# UNITED STATES PATENT AND TRADEMARK OFFICE

APPLICATION NO.	FILING DATE	FIRST NAMED INVENTOR	ATTORNEY DOCKET NO.	CONFIRMATION NO.
10/579,721	05/17/2006	Seiji Omura	062525	3556

## Office Action Summary

FIG. 2

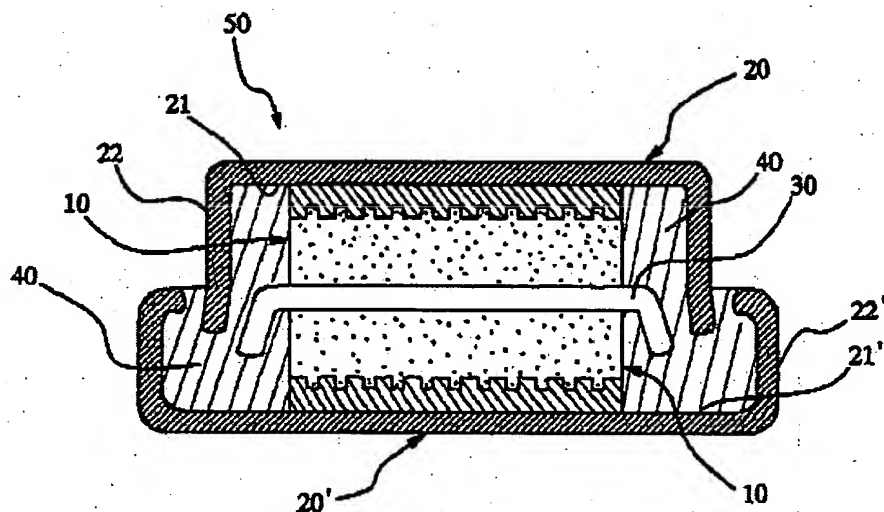
Kwon et al. disclose in fig. 2, An electric double layer capacitor, comprising:  
a separator (30); a pair of polarizing electrodes (10), disposed opposite to each other

with the separator interposed therebetween; an electrolytic solution, impregnated in the pair of the polarizing electrodes and the separator;

an exterior cover (20) and an exterior case (20'), accommodating the separator, the pair of the polarizing electrodes and the electrolytic solution;

and a gasket (40), disposed between the outer circumferential part of the exterior cover and the inner circumferential part of the exterior case, storage space formed by the exterior case and the exterior cover being hermetically sealed by inwardly bending the opening tip portion of the exterior case; wherein no folded-back part is provided at the outer circumferential part of the exterior cover.

Kwon et al. disclose the claimed invention except for the gasket is formed from polyether ether ketone.

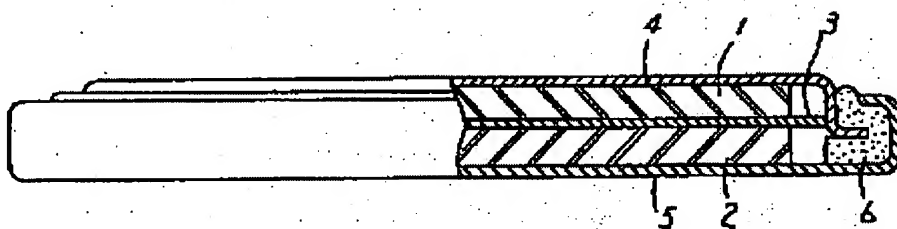
'202 teaches that gaskets formed from polyether ether ketone are excellent in heat resistance.
